Permit Type Building/Residential/Addition/SFD Permit Number B23004799 Opened Date 12/10/2023
 Description of Work SFD/ CONSTRUCT 18 X 24 (1)STORY ADDITION FOR FAMILY ROOM/; 1 STORY, Full Basement. 0R, 0FB, 0HB, 0FP, OTHER STRUCTURE = None, 0BR, PORCH/DECK = Optional Deck, ENERGY METHOD = N/A.

Herboldt Residence

Proposed Addition to the

Onsite Sewage Disposal System Design Plan

LOT 11 SEC 2
SUNSET VALLEY

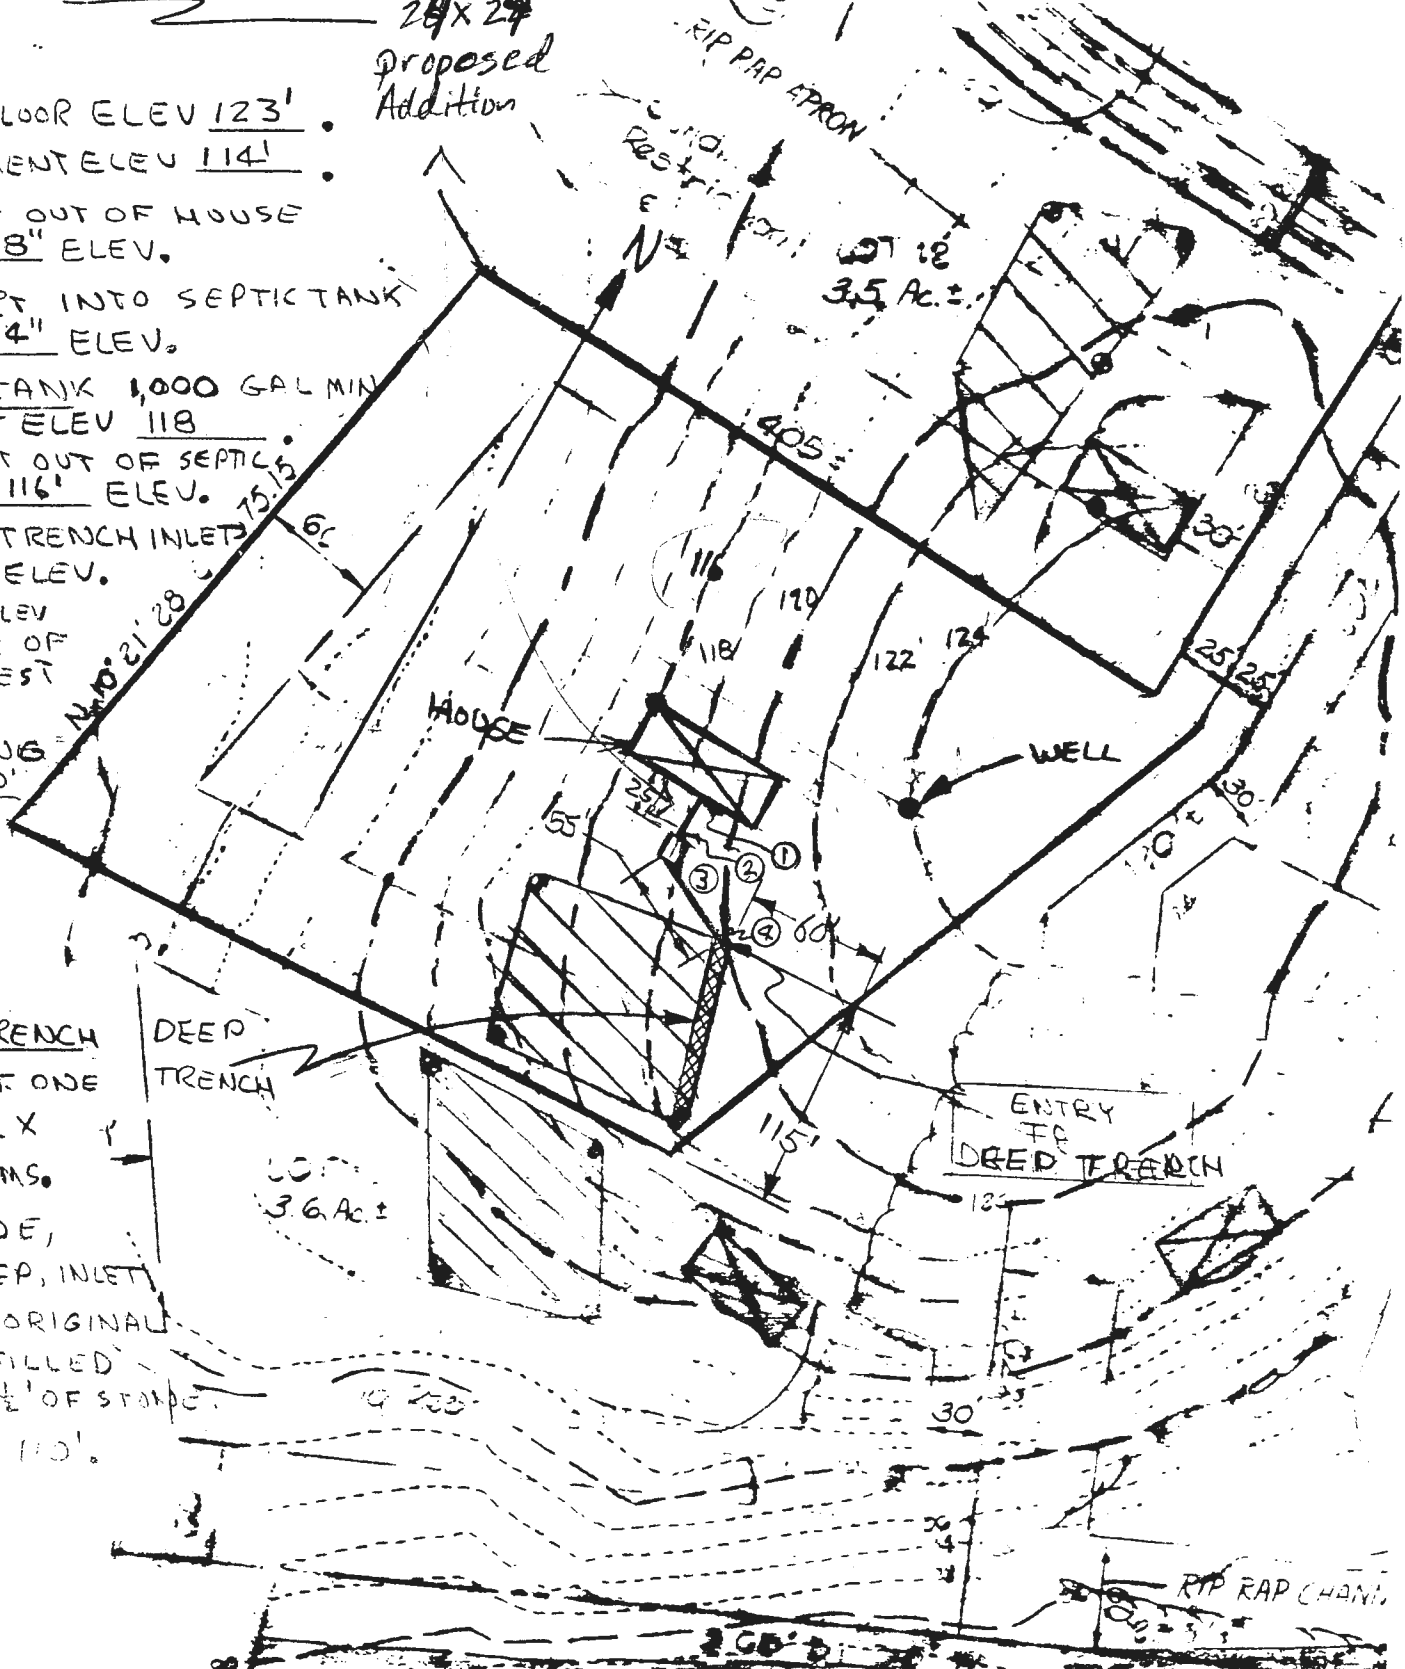
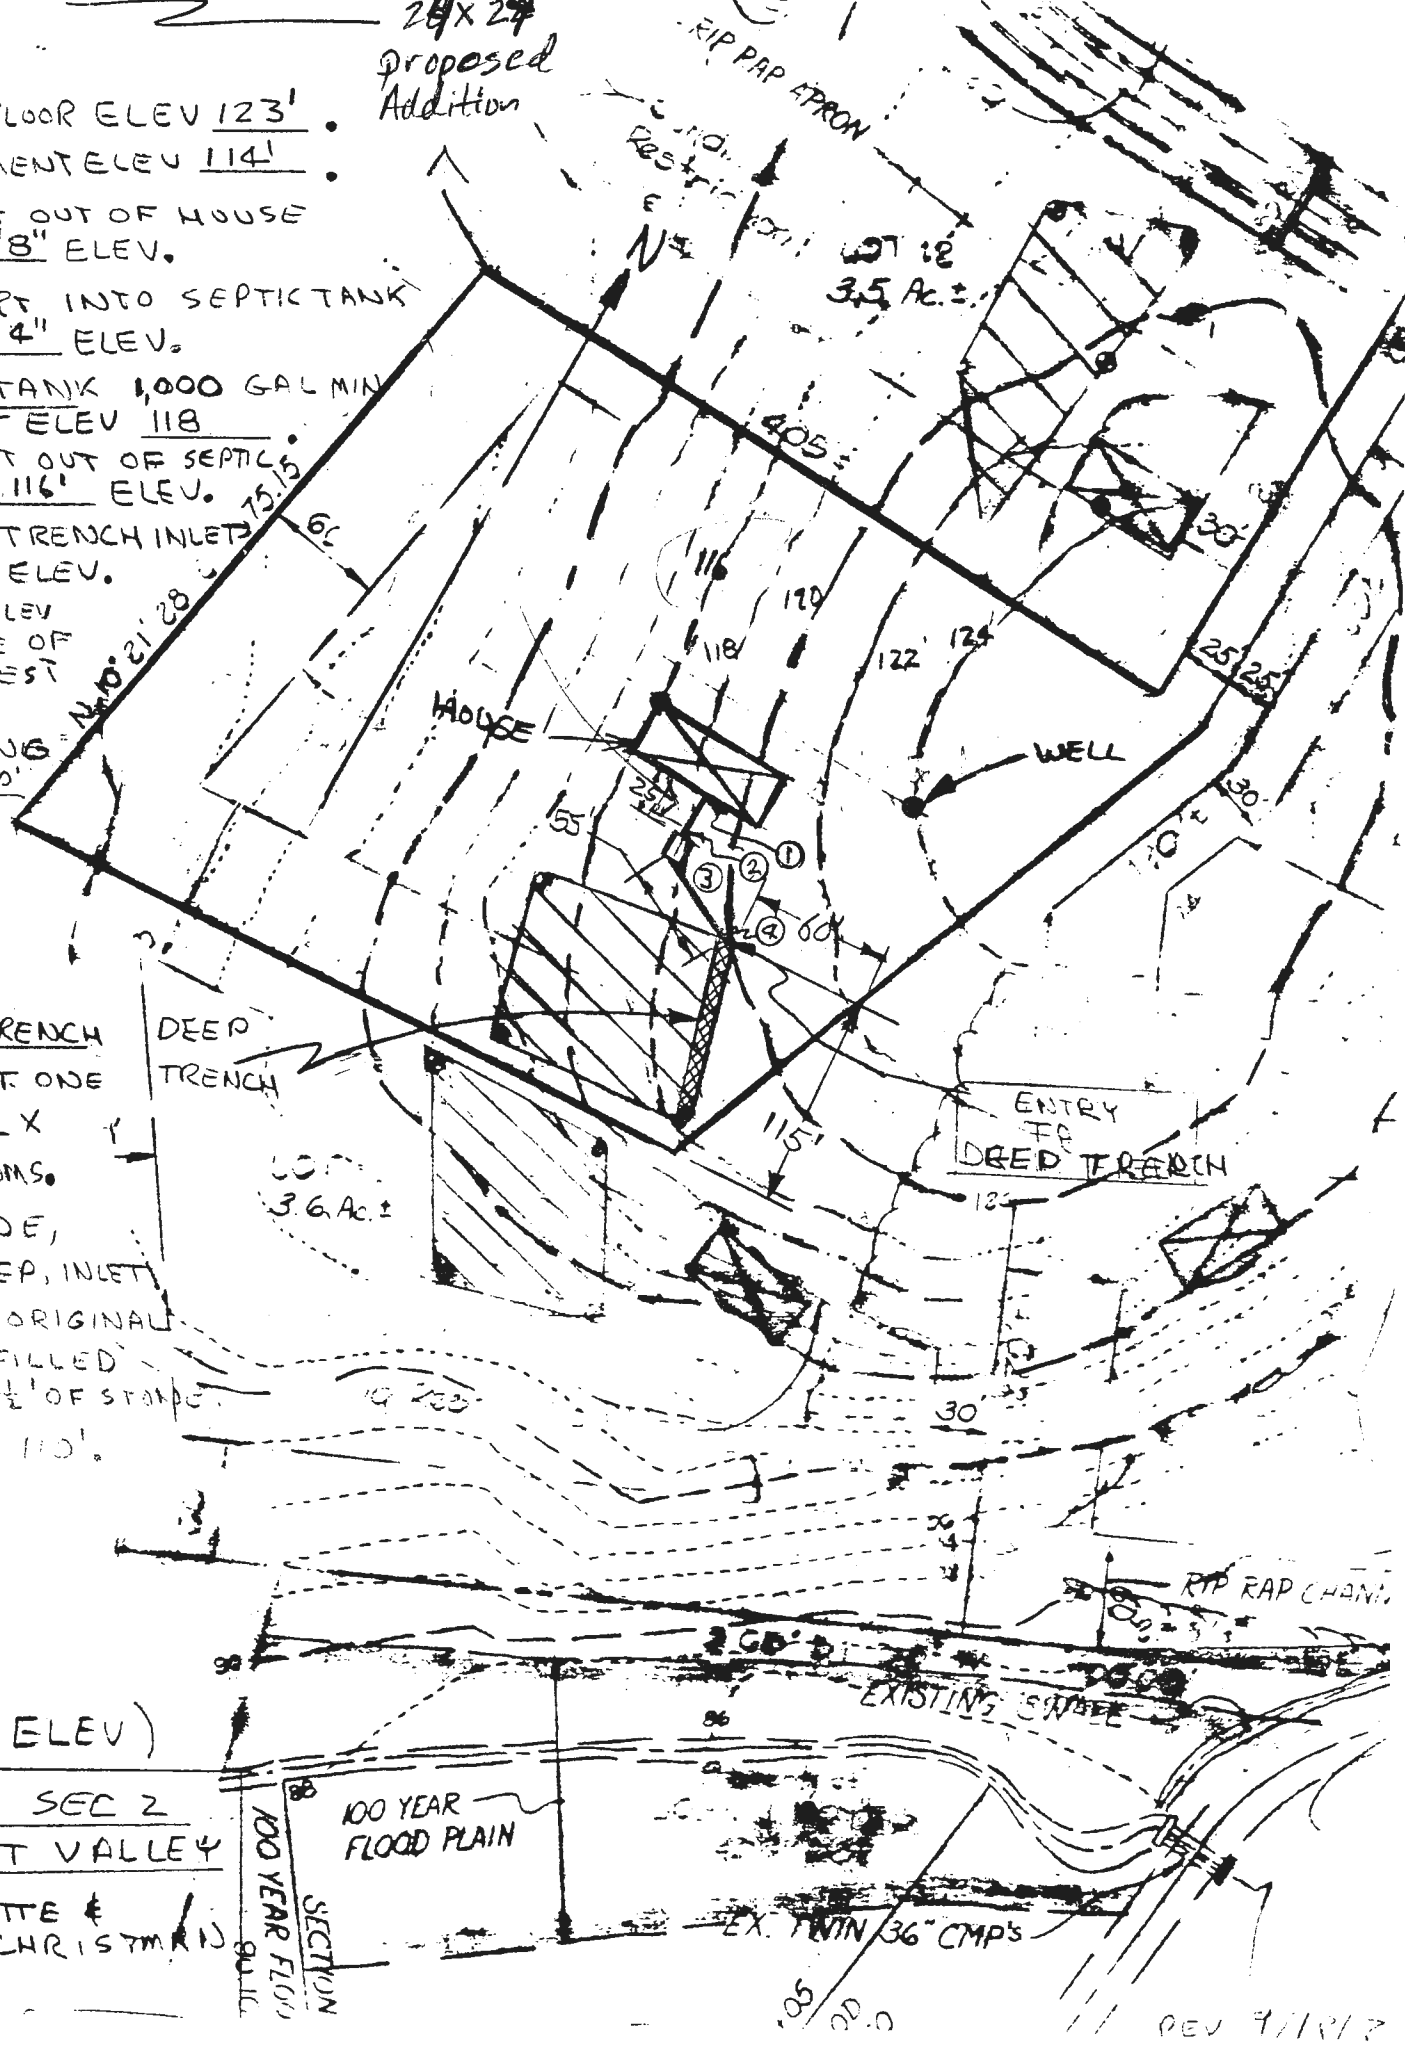
Please revise the site plan to scale between 1:30 to 1:100 showing all existing structures plus proposed addition, the well and septic system components including the sewage disposal area. The revised site plan should be submitted to the permits office with one copy labeled for Health.
